**EXHIBIT 1
FIRST AMENDMENT
TO
DEVELOPMENT AGREEMENT**

This First Amendment to Development Agreement (this “*First Amendment*”) is dated for reference purposes March __, 2014, and is made and entered into by and between the CITY OF EVERETT, a municipal corporation of the State of Washington (the “*City*”), and PNW RIVERFRONT, L.L.C., a Washington limited liability company (“*Polygon Residential Developer*”), and RIVERFRONT COMMERCIAL, LLC, a Washington limited liability company (“*Polygon Commercial Developer*”). Polygon Residential Developer and Polygon Commercial Developer are collectively referred to in this First Amendment as “*Polygon*.”

Preliminary Development Plan – Revised Simpson and Eclipse Neighborhood Plans (Replaces pg. 1 of Attachment E to Dev. Agreement)

Pg. 6
(Concept Plans
Simpson
Neighborhood)

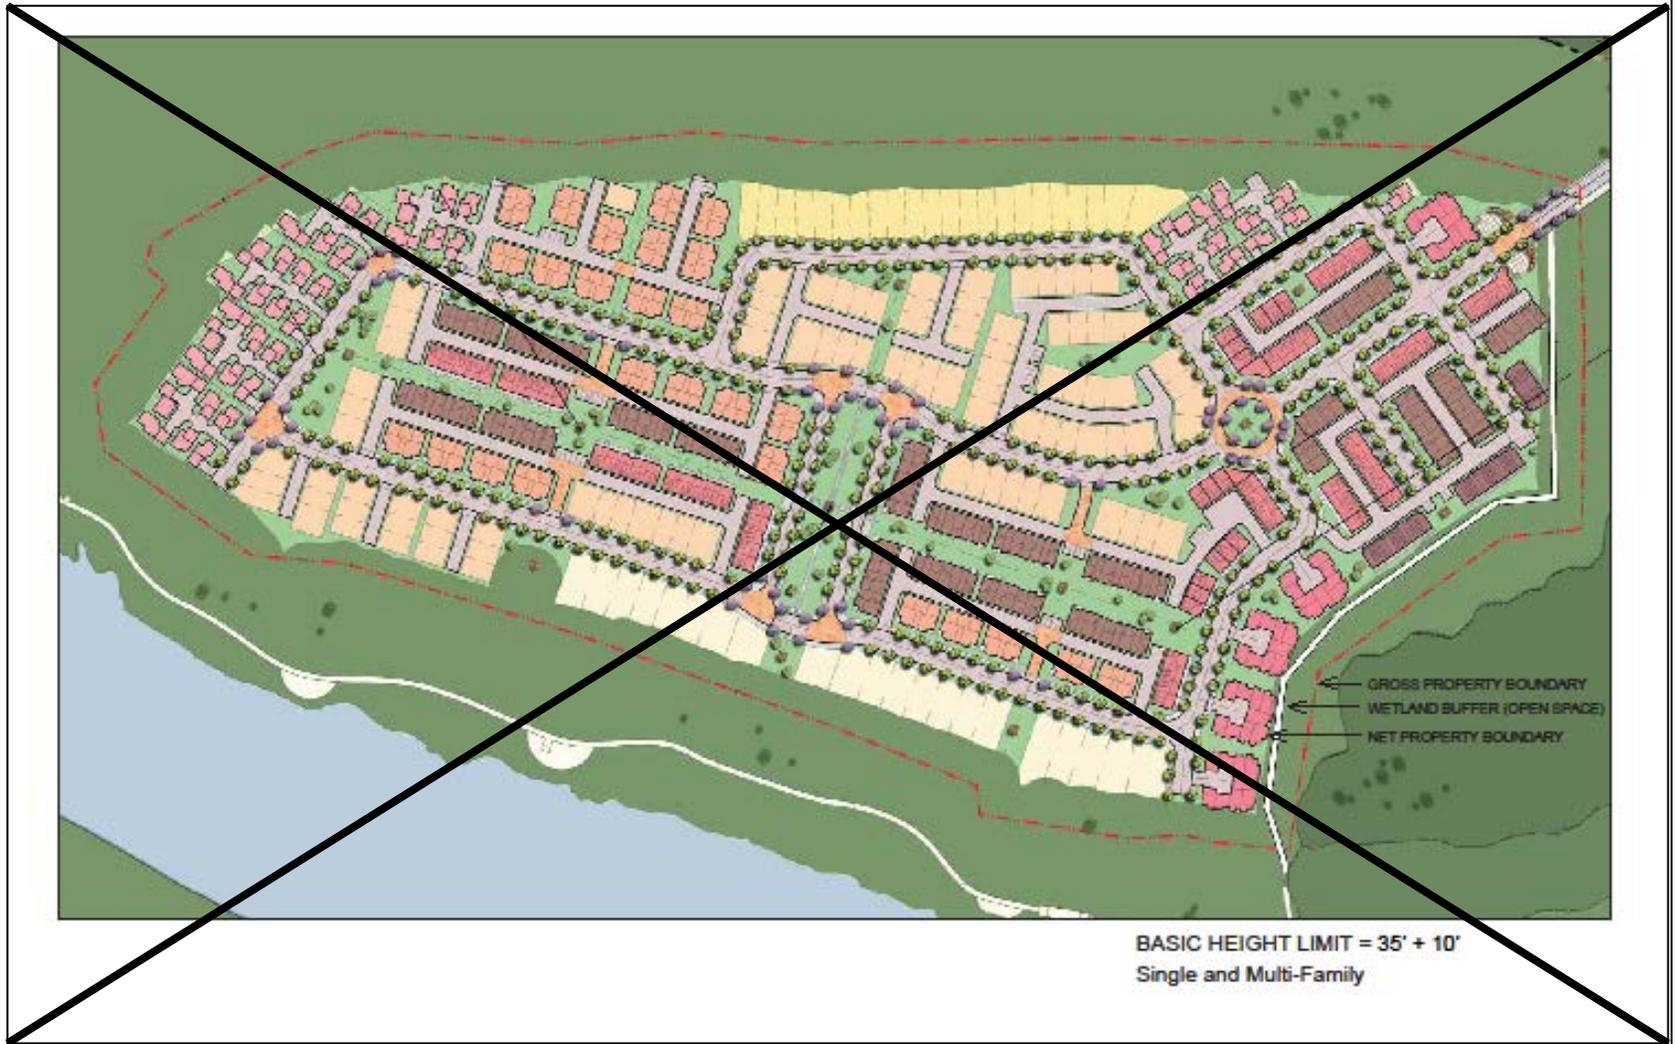
Delete existing plan

Concept Plans Simpson Neighborhood

Concept Plans Eclipse Neighborhood

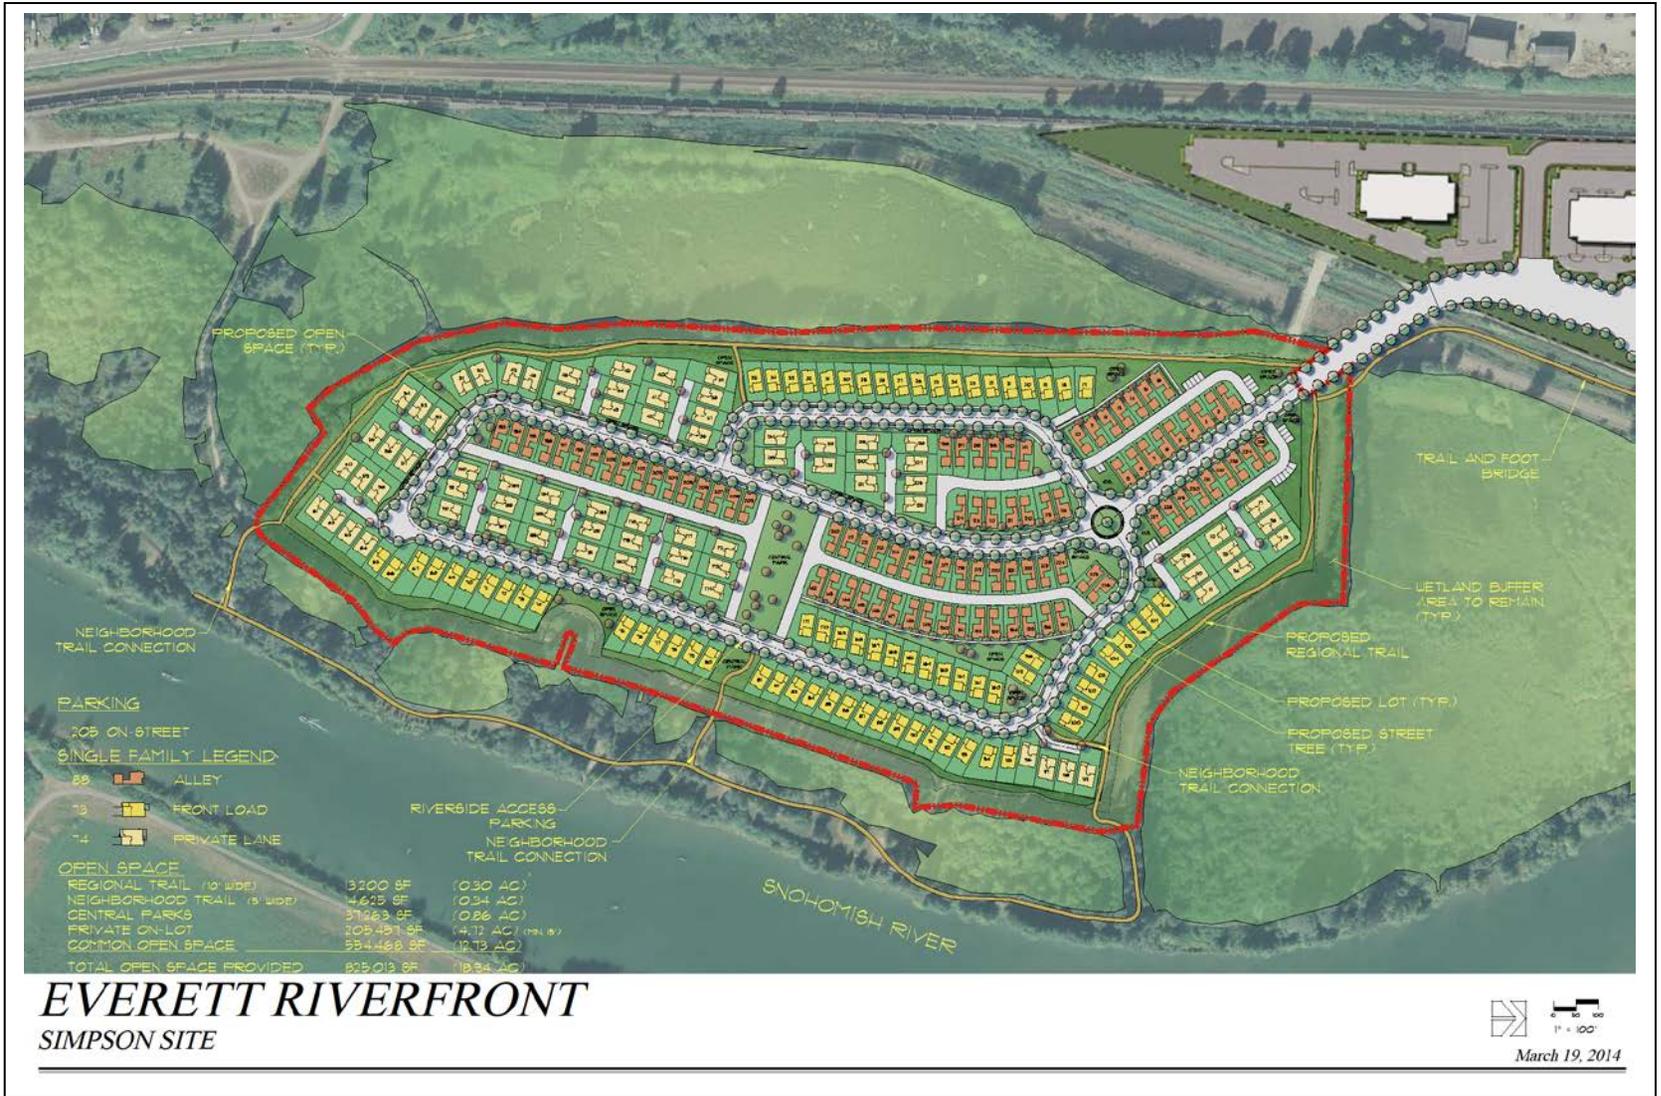
EVERETT RIVERFRONT
ECLIPSE SITE

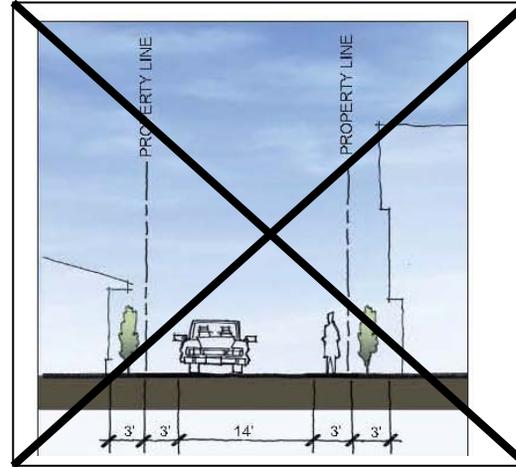
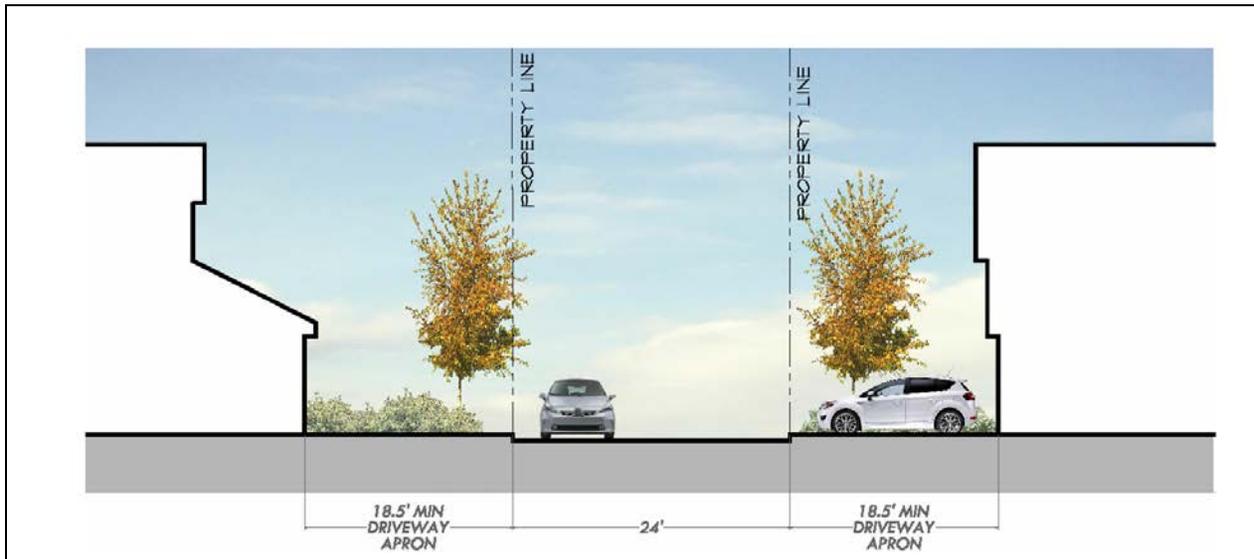
Delete Existing Graphics for Alley / Lane

Add ~~Proposed~~ Graphics for Private Access Lanes

Private access lanes are required to be constructed of concrete pavers, stamped asphalt, or other decorative and distinctive paving features as approved by the City Engineer.

Private alleys are also 24 feet wide. However, an 18.5 foot driveway apron is not required. Distance from the garage to the opposite side of the alley must be a minimum of 26 feet.

Pg. 12 (open space)

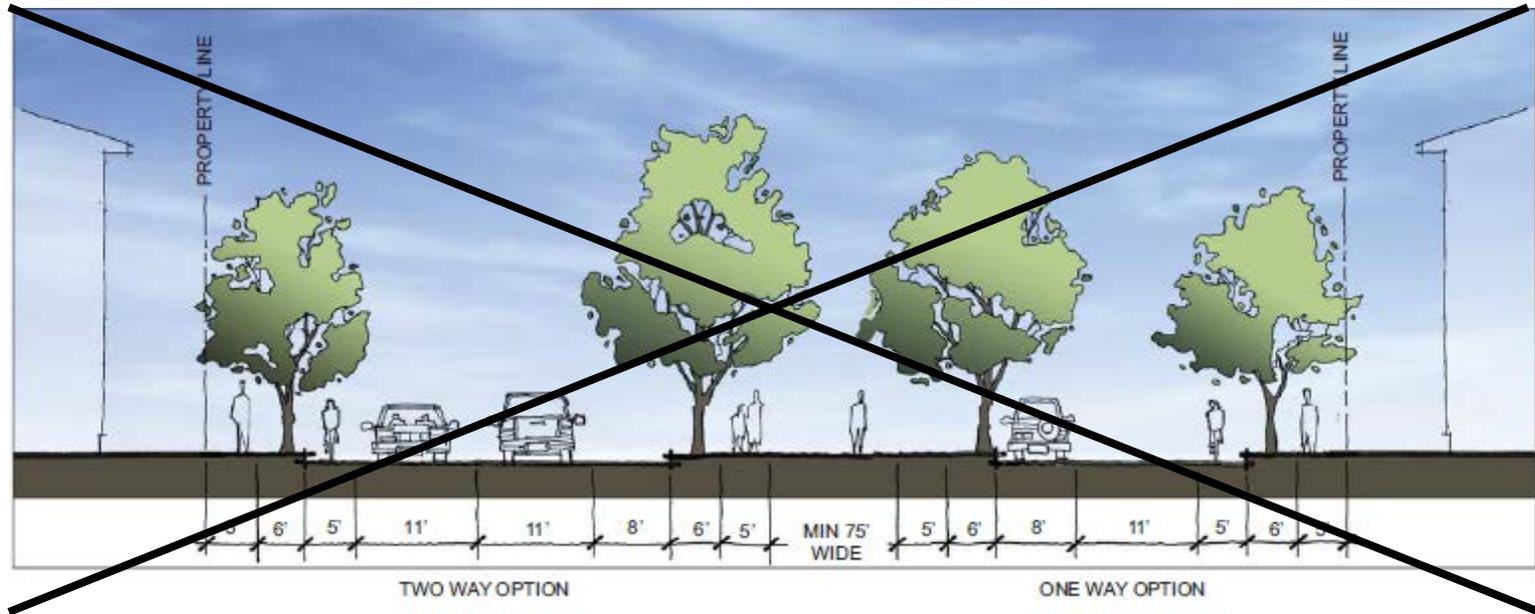
The existing graphic for the neighborhood green is deleted:

Pg. 29 (Lot width for single family – small lot)

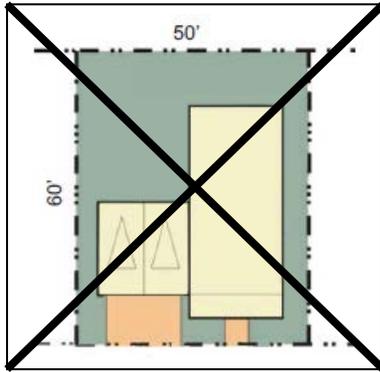
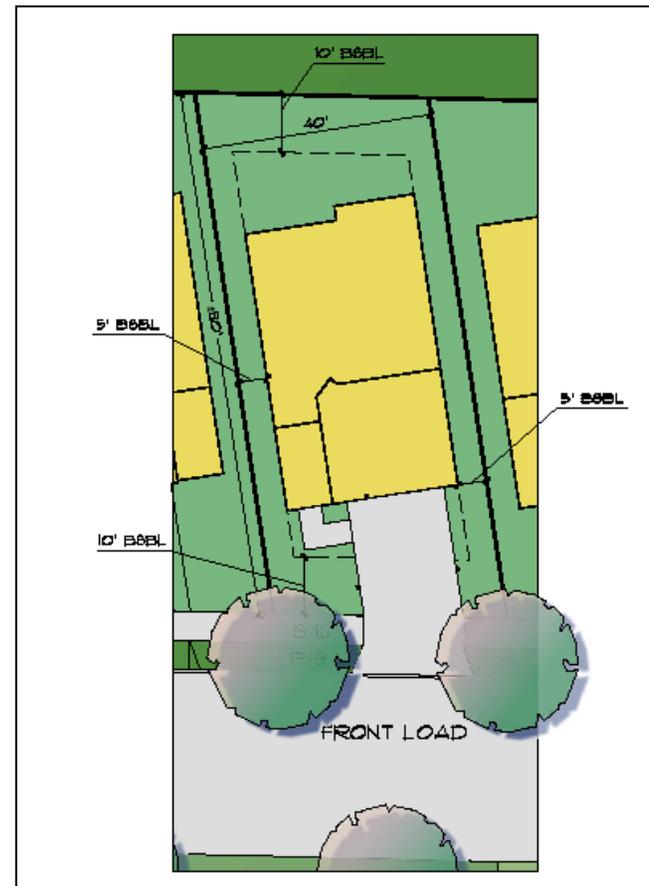
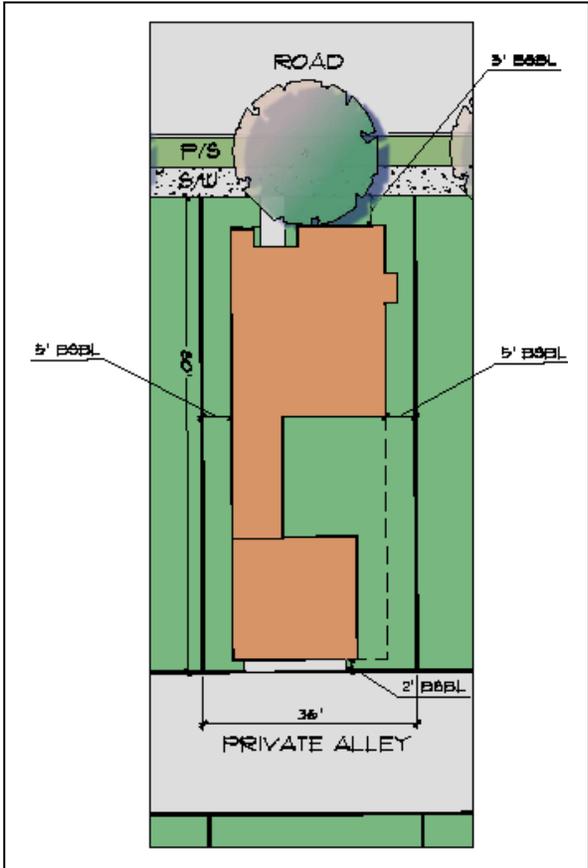
Delete graphic showing 50' lot width

Add graphics showing narrower front-loaded angled lots and an alley-loaded lot

Pg. 30 (Lanes)

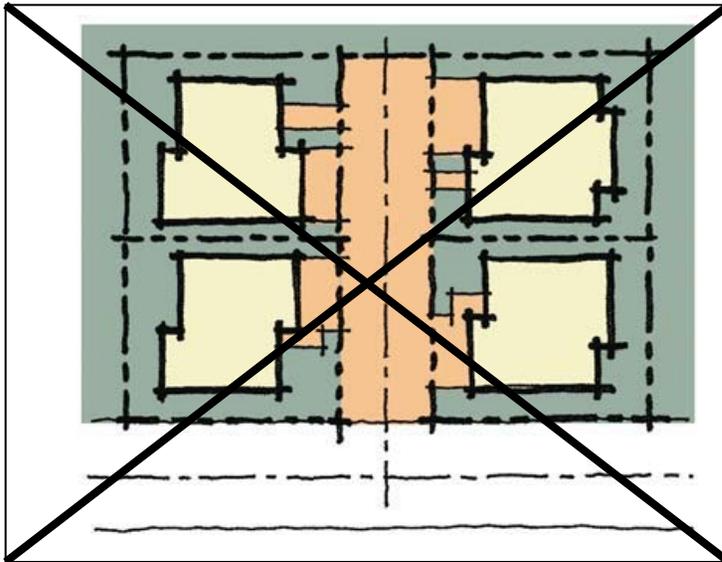
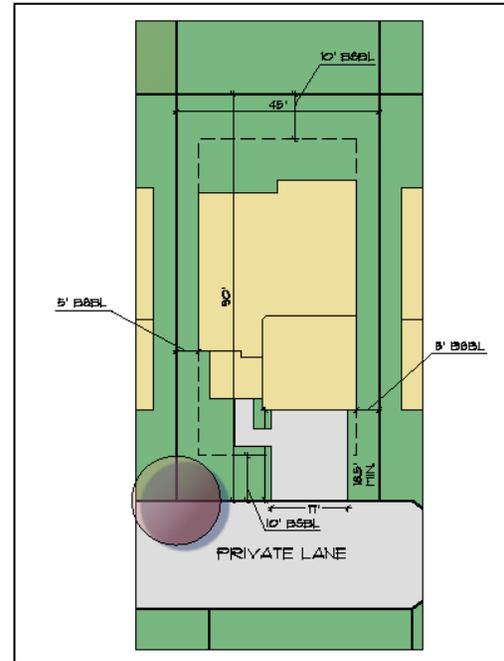
delete existing graphics

add new graphics
